**Response to**  
**Request for Additional Information No. 537**  
**Supplement 1**

**U. S. EPR Standard Design Certification**  
**AREVA NP Inc.**  
**Docket No. 52-020**  
**SRP Section: 06.02.01 - Containment Functional Design**  
**Application Section: 6.2.1**

**Question 06.02.01-104:**

Figure 3D-1—Typical Combined LOCA/SLB Inside Containment Temperature Service Conditions Envelope

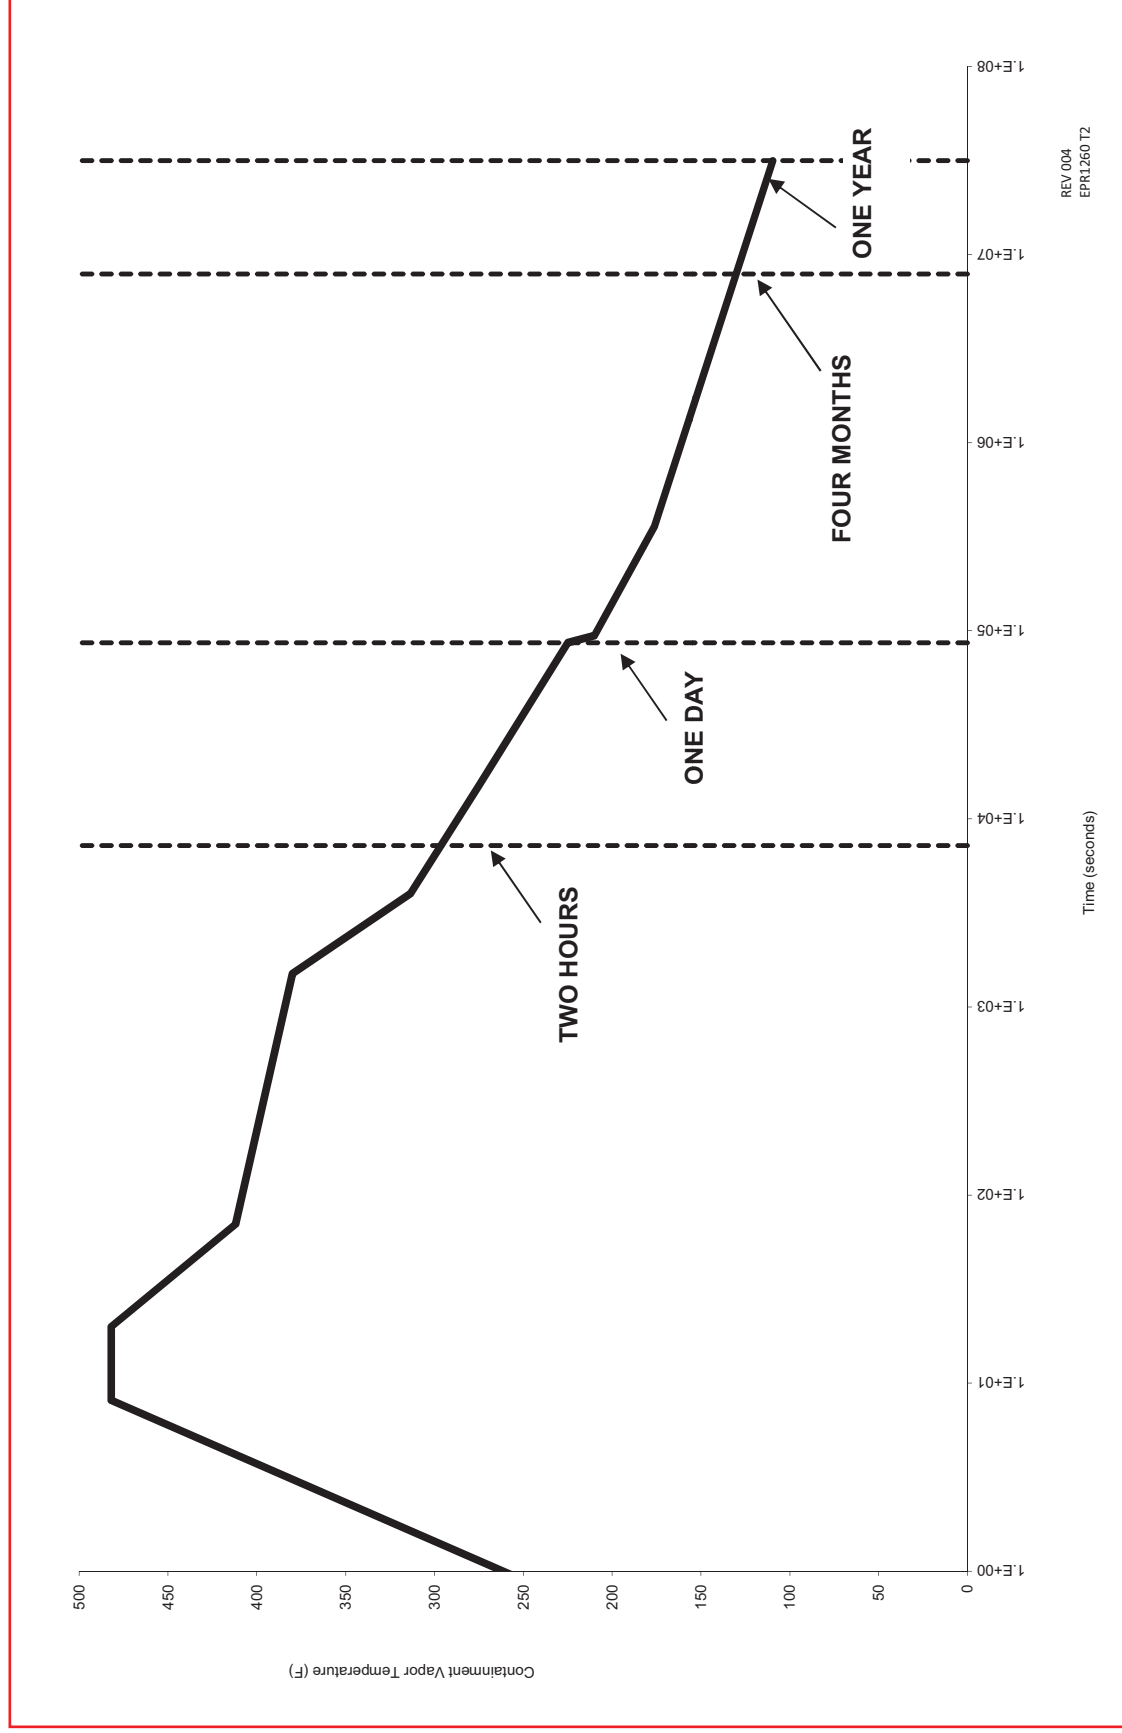
The information as provided in the RAI No. 368, Supplement 10 response for Question 06.02.01-80, Table 06.02.01-80-1 and Figure 06.02.01-80-1, presents the bounding temperature envelope for environmental qualification that captures all LOCA and MSLB cases. The RAI response concludes that the FSAR will not be changed as a result of this question. Staff notes, the EQ temperature curve as shown in Figure 3D-1 of Tier 2 FSAR Rev.3 is significantly non-conservative as compared to the temperature envelope provided in this RAI response. Staff requests the applicant address the non-conservatism of FSAR Rev.3 EQ temperature curve (Figure 3D-1) against this RAI response and resolve their inconsistency.

U.S. EPR FSAR Tier 2, Appendix 3D, Figures 3D-1 and 3D-2 will be revised to reflect the revised temperature and pressure envelope as a result of the response to RAI No. 368, Supplement 10.

U.S. EPR FSAR Tier 2, Appendix 3D, Figures 3D-1 and 3D-2 will be revised as described in the response and indicated on the enclosed markup.
